Access Compliance Report

Public Rights-of-Way

(Pedestrian Signals)

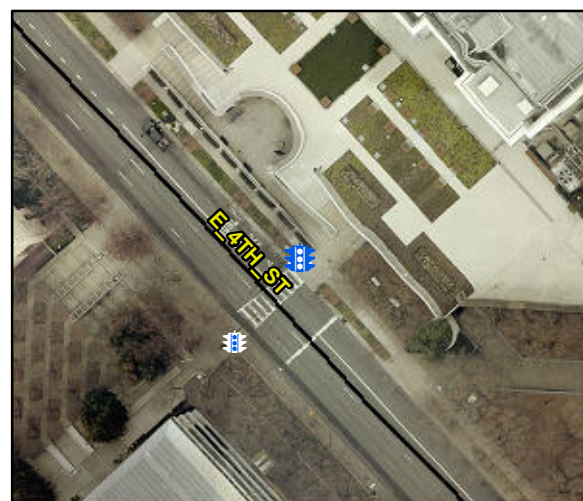
Intersection ID: N/A	Main Street:	Cross Street: N/A	Location: N/A
ADA ID: 5476CEEDF35B	Signal Type: One Push Button-Non APS	Overall Compliance: No	Severity Score: BTN 1: N/A BTN 2: N/A No BTN: N/A
Codes/Mitigation Info/Possible Solution		Field Measurements/Component Compliance

PROW/ADA: R404.2, R404.3, R406.2, R404.7.3

Possible Solutions: Remove and Replace Clear Space.
